ADDENDUM NO. 2

July 29, 2026

The Solanco Area School District | New District Administration Offices & Turf Fields
CRA Project No. 3706

CRABTREE ROHRBAUGH & ASSOCIATES - ARCHITECTS

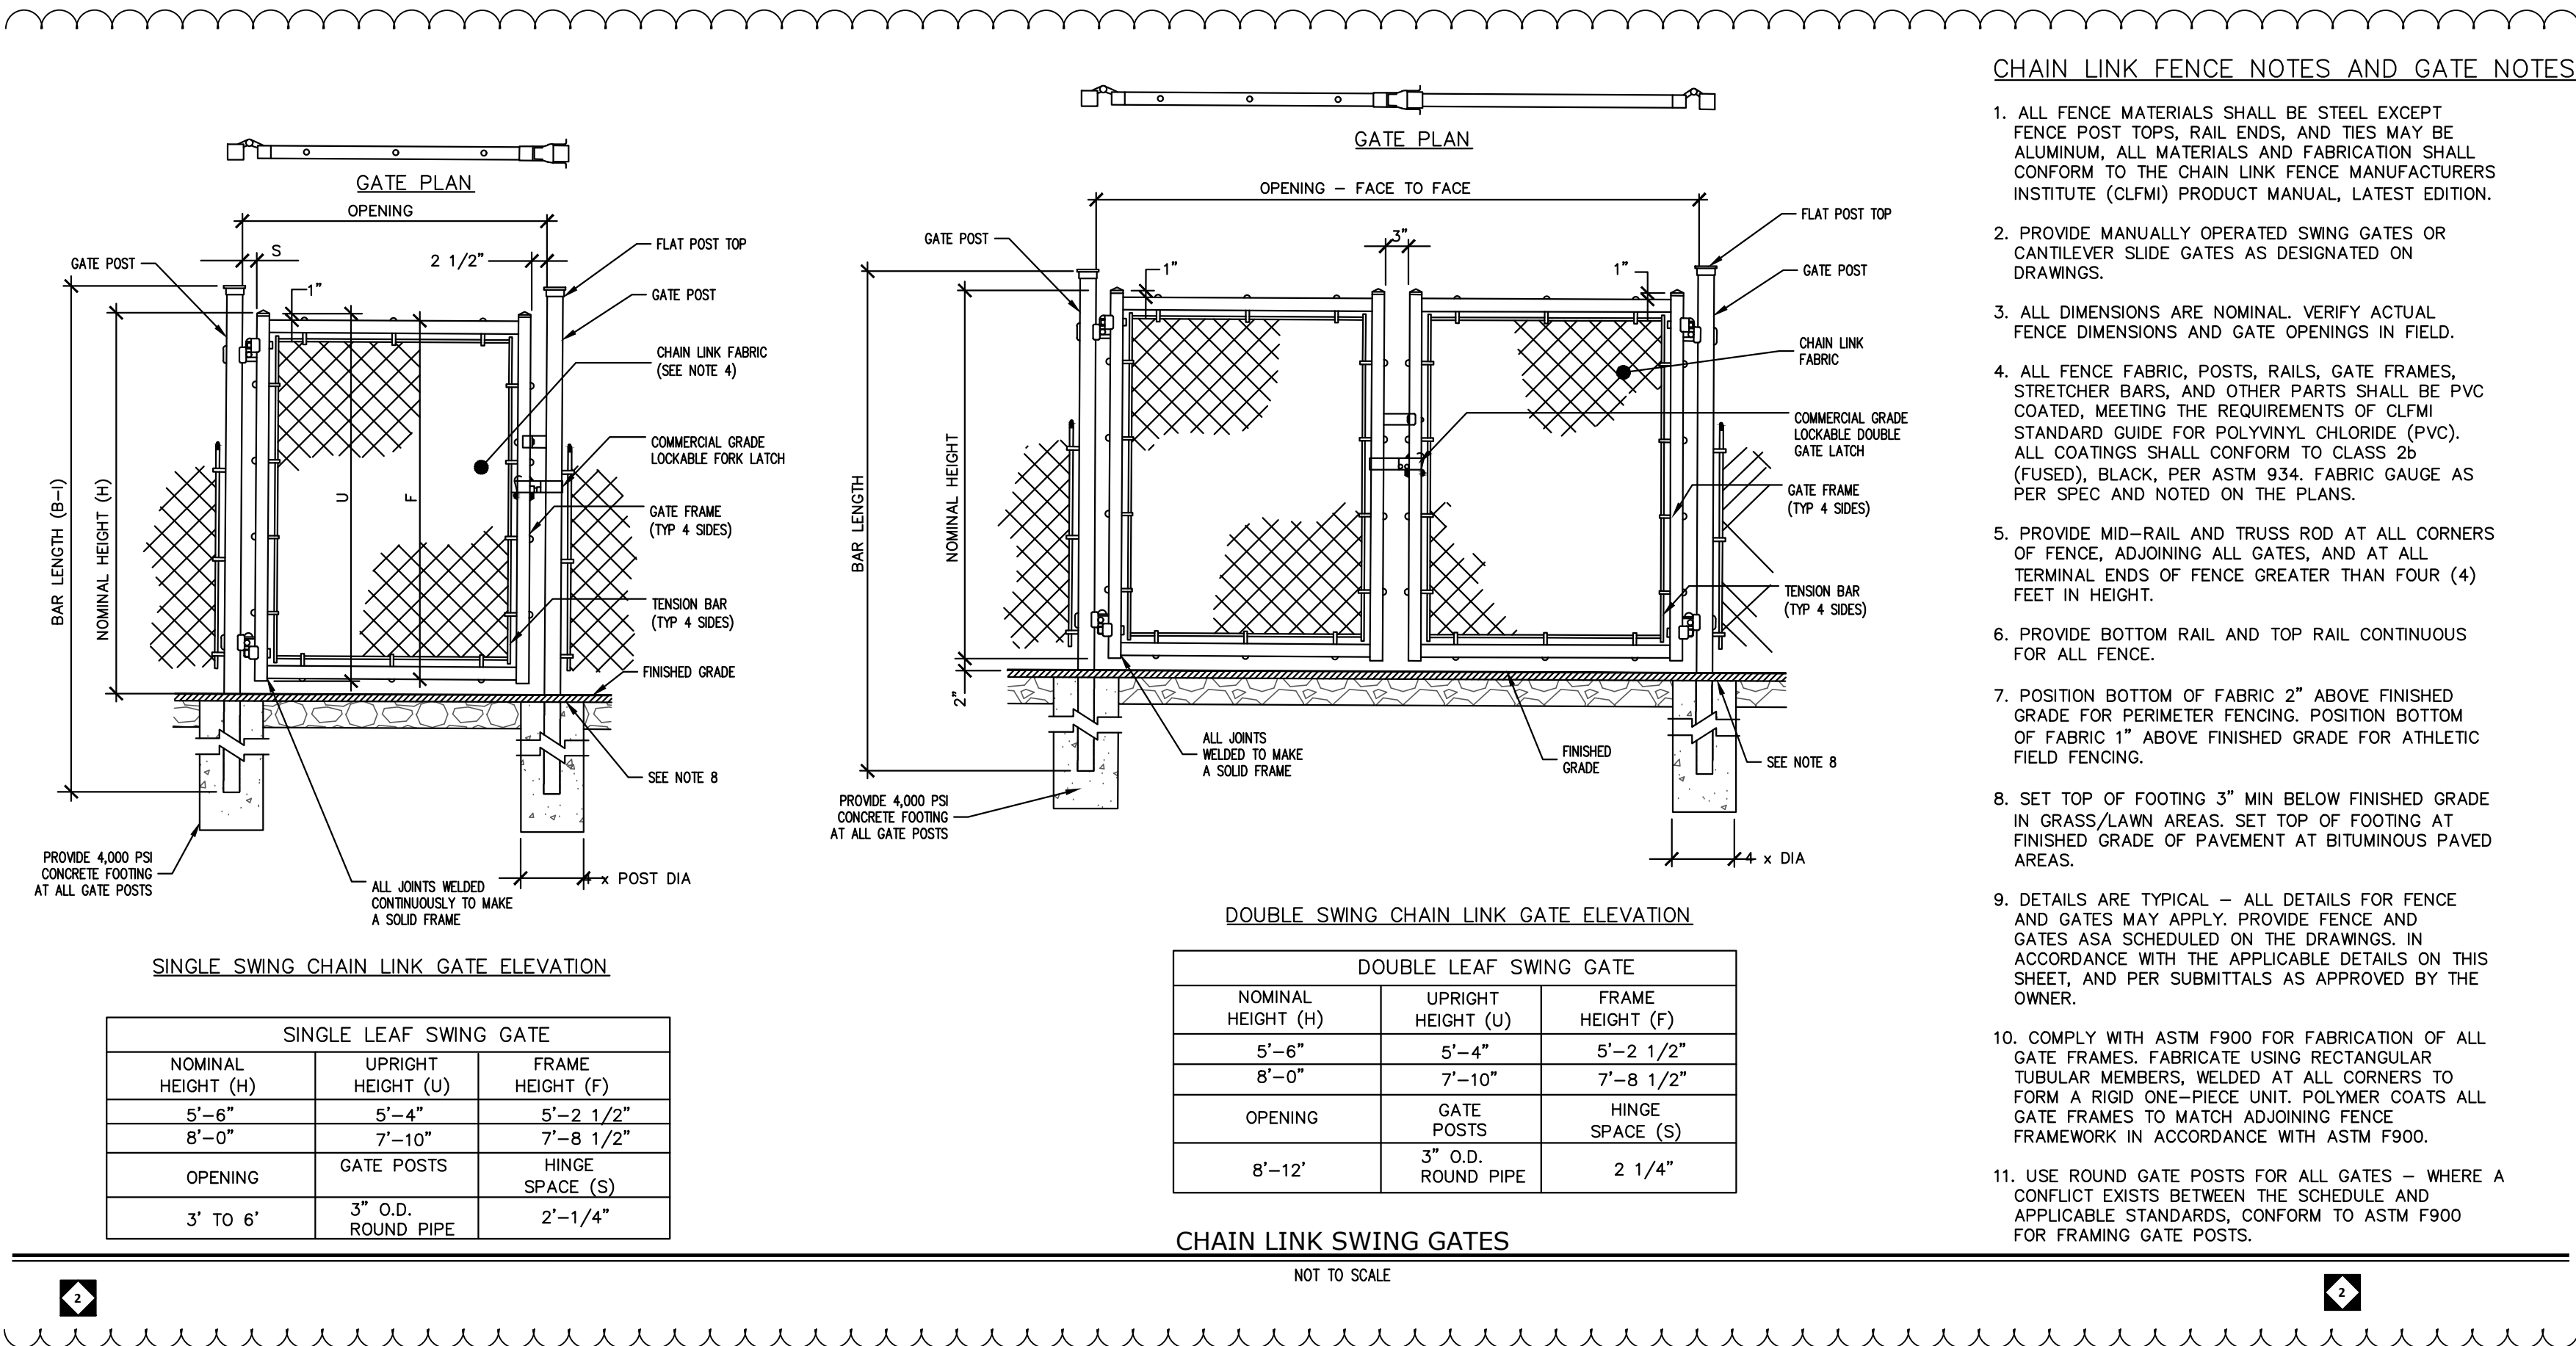
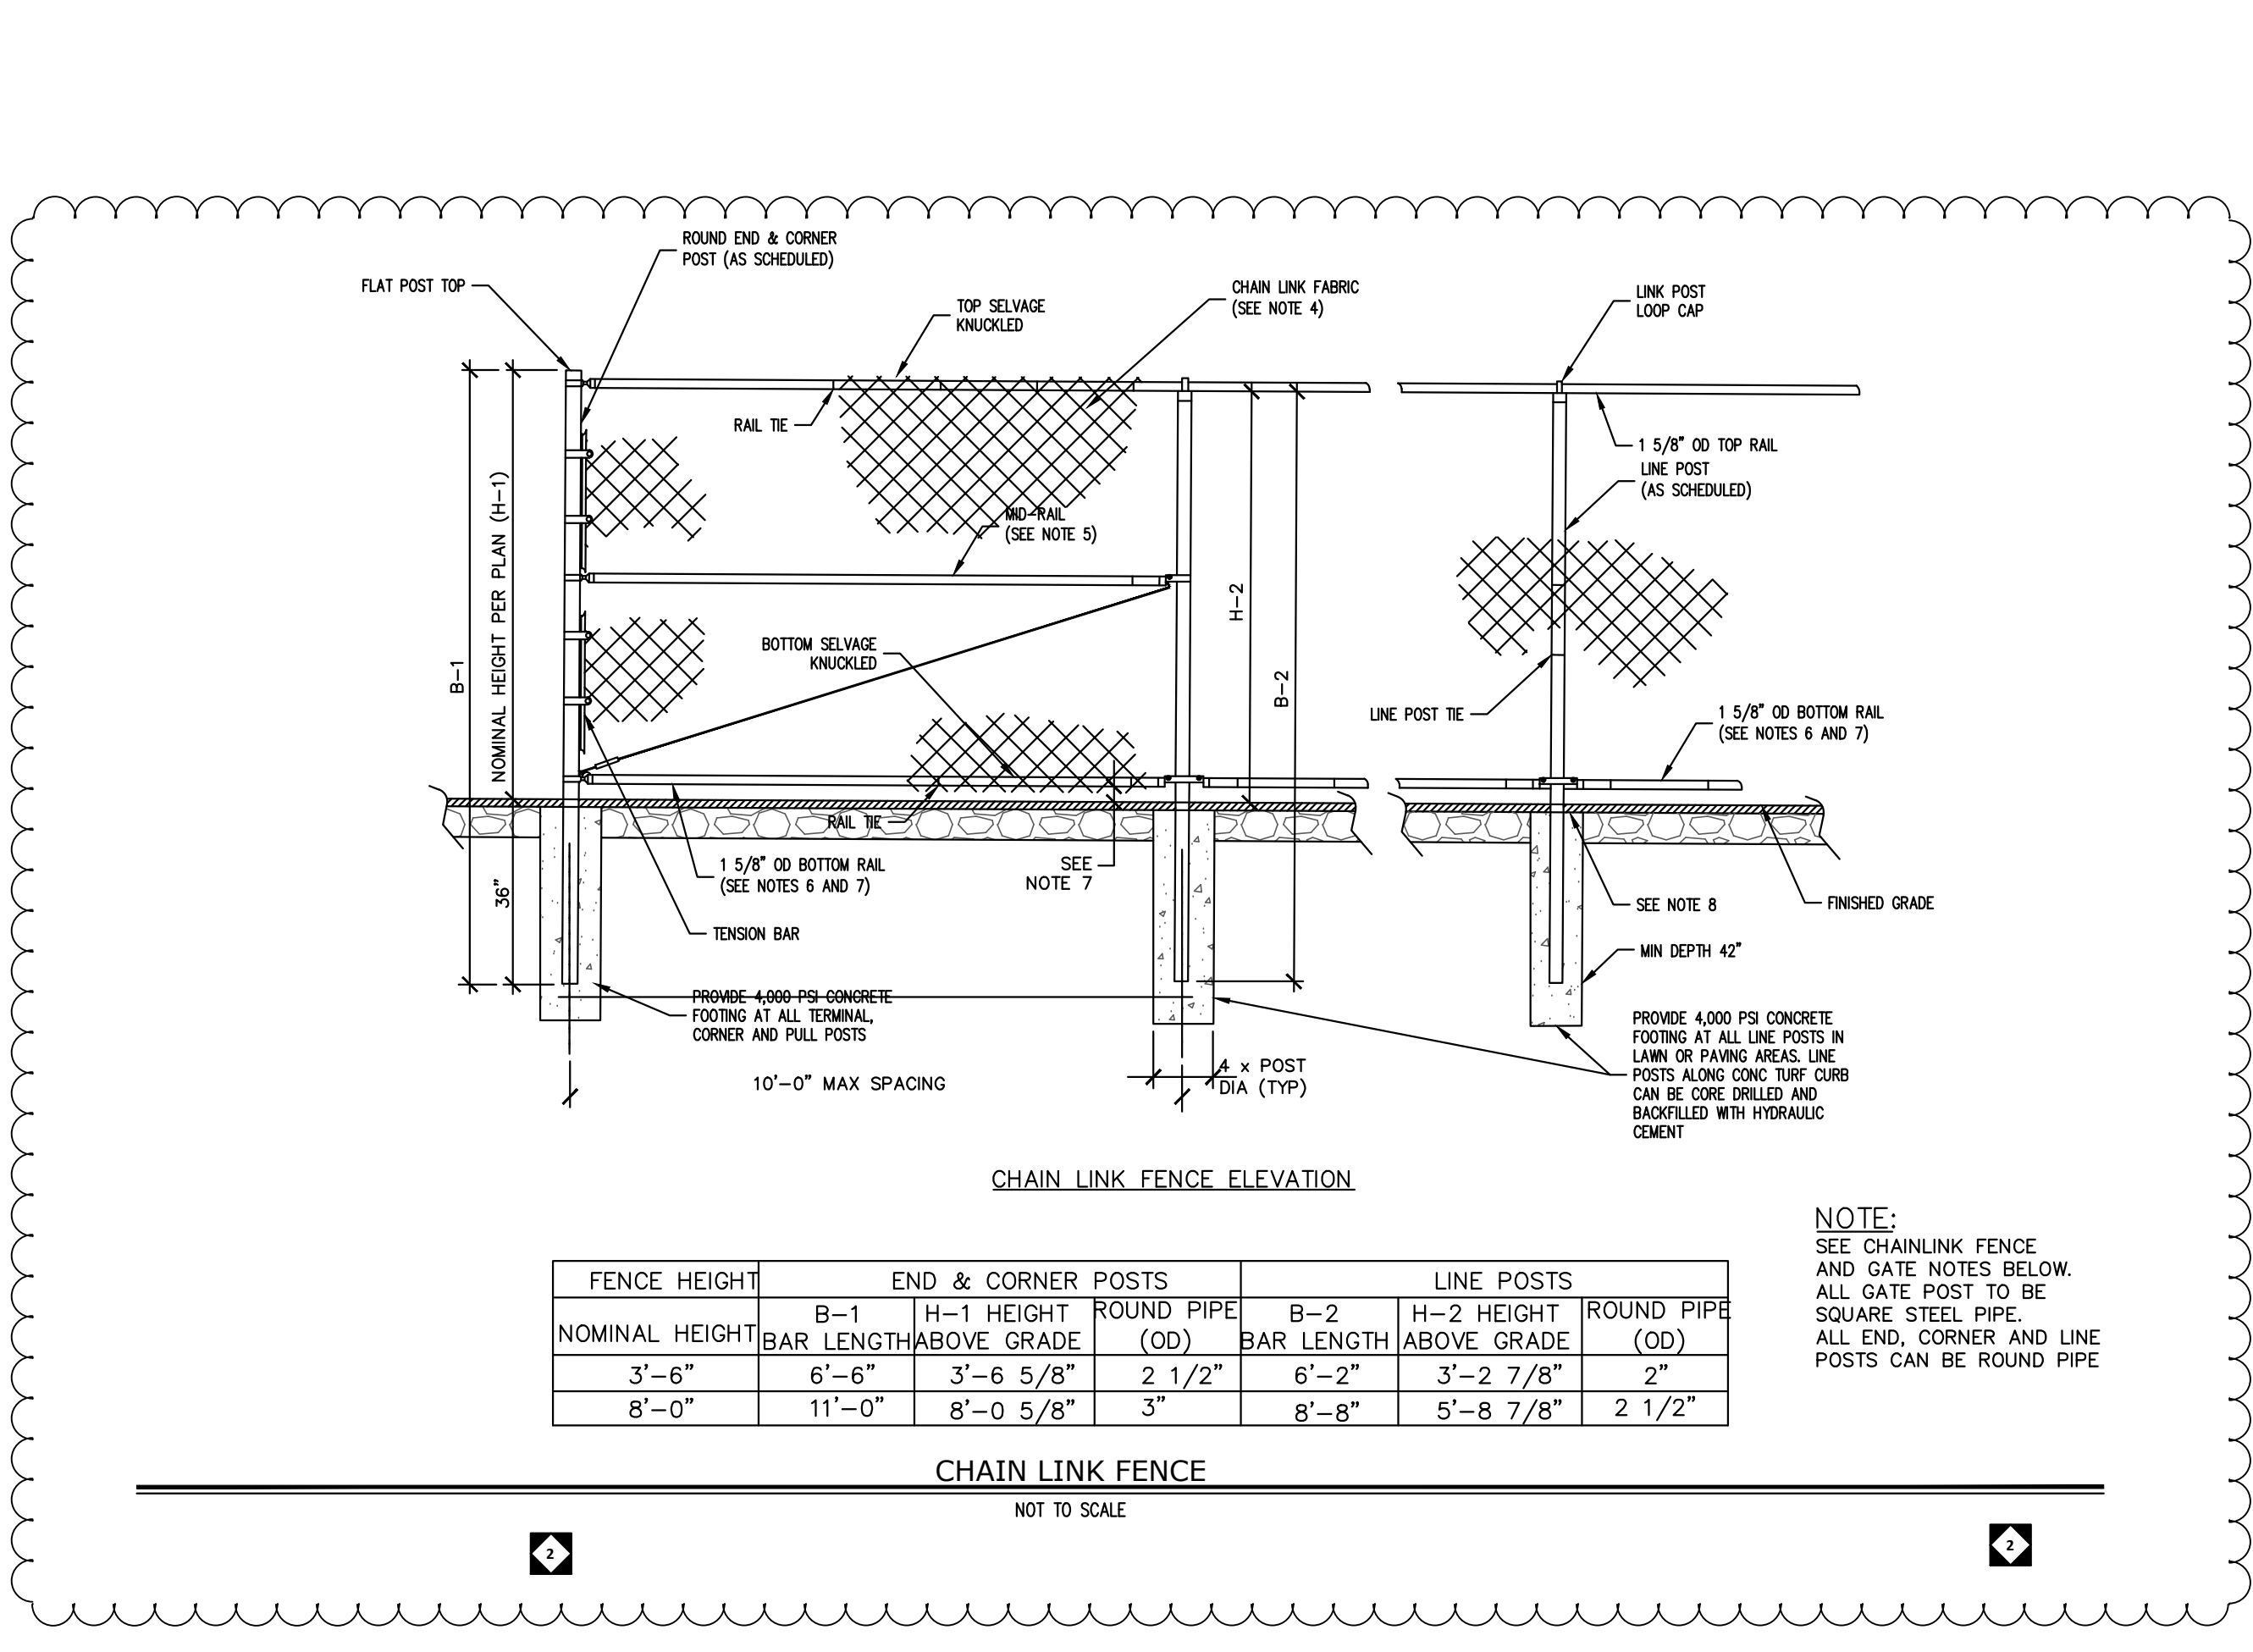
DRAWING C-604– DETAILS

1. **REVISED** the detail name to “PERIMETER TURF CURB WITH INTEGRAL FENCE”.
